# WATER QUALITY MEMORANDUM

## Utah Coal Regulatory Program

RE: 2009 4<sup>th</sup> Quarter Water Monitoring, Canyon Fuel Company (CFC), LLC, Dugout Mine, C/007/0039-WQ09-4, Task ID #3431

Spring SC-116: D-Ca, SO4, TDS vs. Time

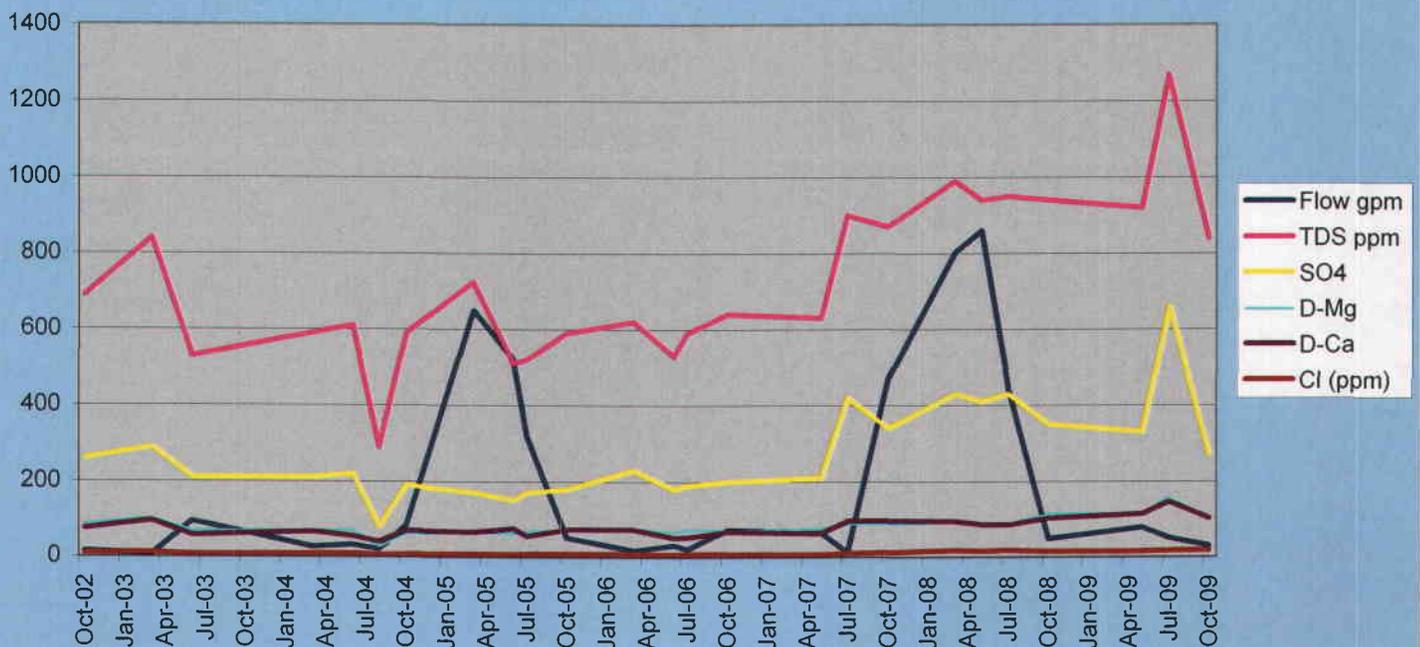
**SC-116** The previous two quarters (WQ09-2 and WQ09-3), SO<sub>4</sub>, TDS and T-Cats were reported outside of two standard deviations. Additionally, dissolved calcium (D-Ca) was

reported outside of two standard deviations the previous quarter (WQ09-3). This quarter, all required parameters were reported within two standard deviations of the mean. (See Chart Below)

### Stream Monitoring Site PC-2

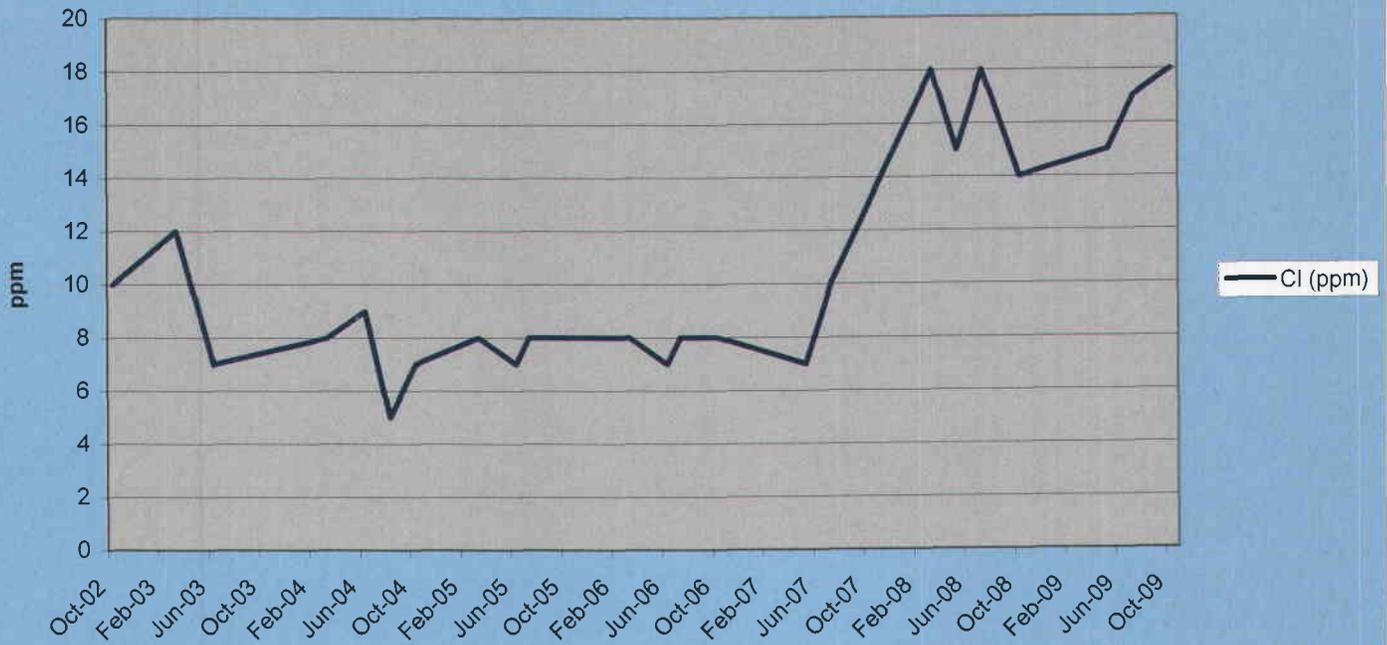
During the previous two quarters (WQ09-2 and WQ09-3), site PC-2 has reported several parameters outside of two standard deviations (D-Ca, D-Mg, total alkalinity, bicarbonate, field conductivity, Cl, total cations, total anions, SO<sub>4</sub> and TDS). This quarter, Cl, total alkalinity and bicarbonate were again reported outside of two standard deviations. (See Chart Below)

### Monitoring Well GW-10-2

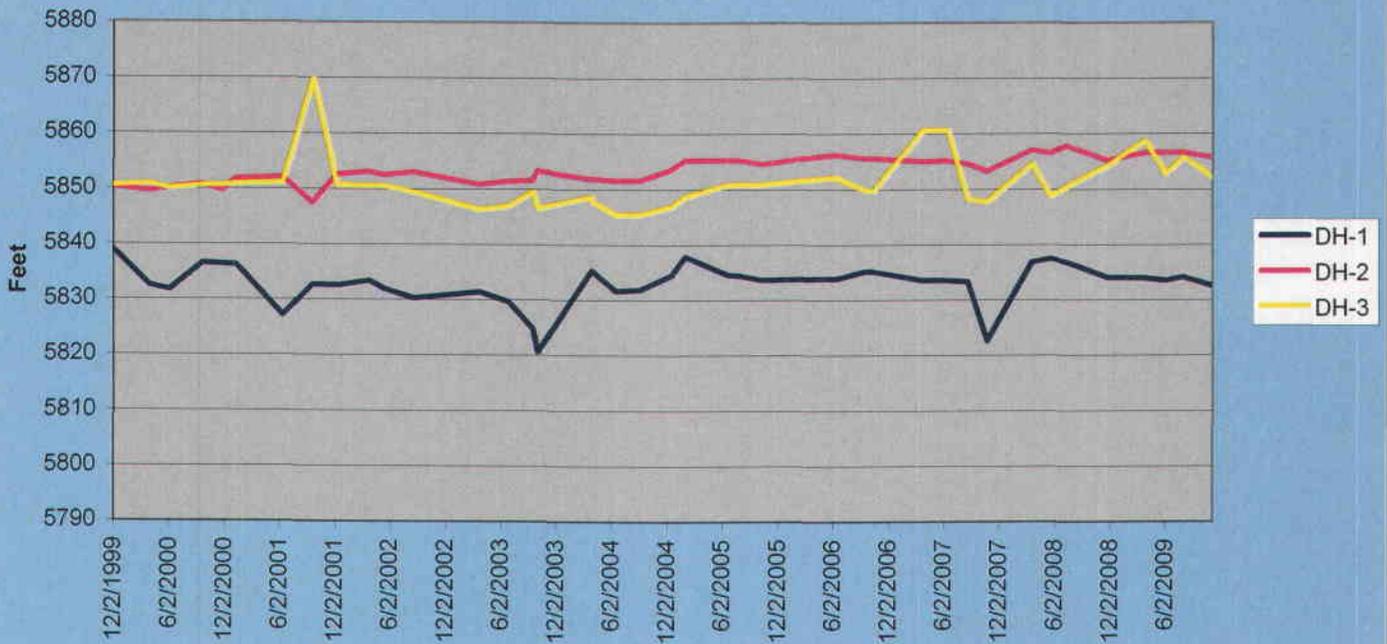
For the second consecutive quarter, monitoring well GW-10-2 reported a depth to water outside of two standard deviations from the mean. Continued monitoring of water levels in well GW-10-2 will be conducted to ascertain if a downward trend is emerging. (See Chart Below)

### DC-1: D-Na, TDS and Flow vs. Time

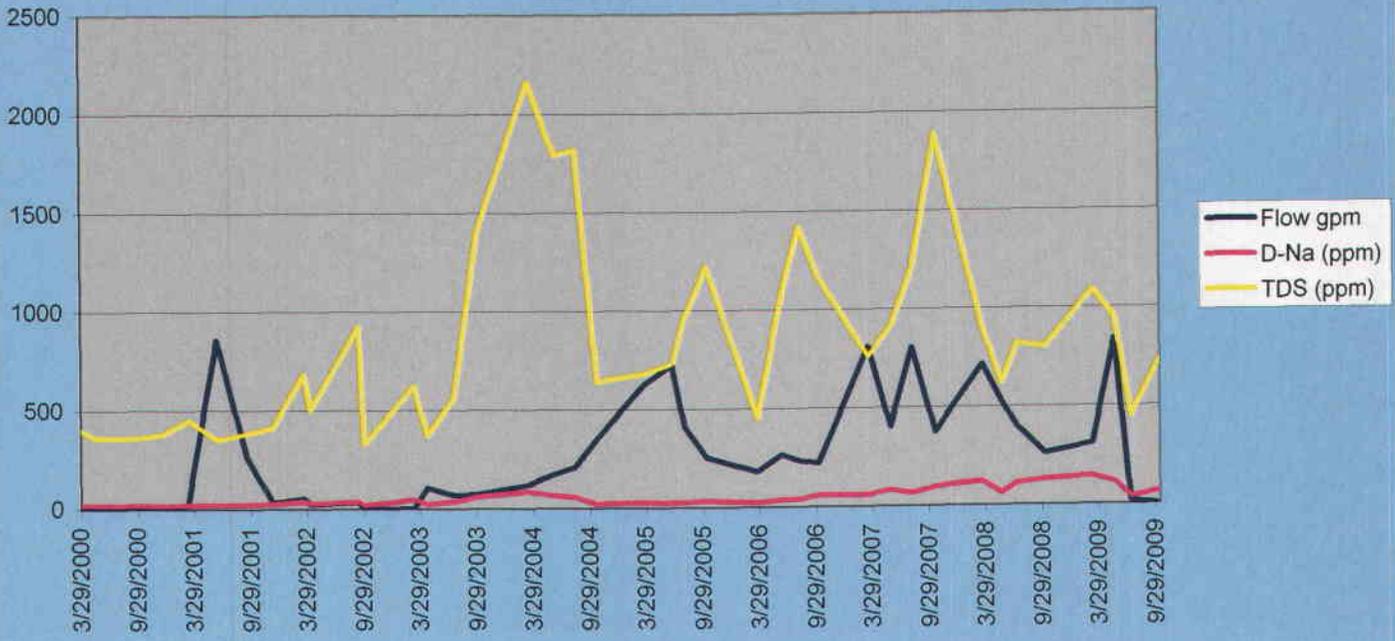
DC-1 reported a D-Na concentration within two standard deviations of the data set for the second consecutive quarter. Historically, this site has produced erratic D-Na trends typified by spikes in the late spring/early summer. (See Chart Below)
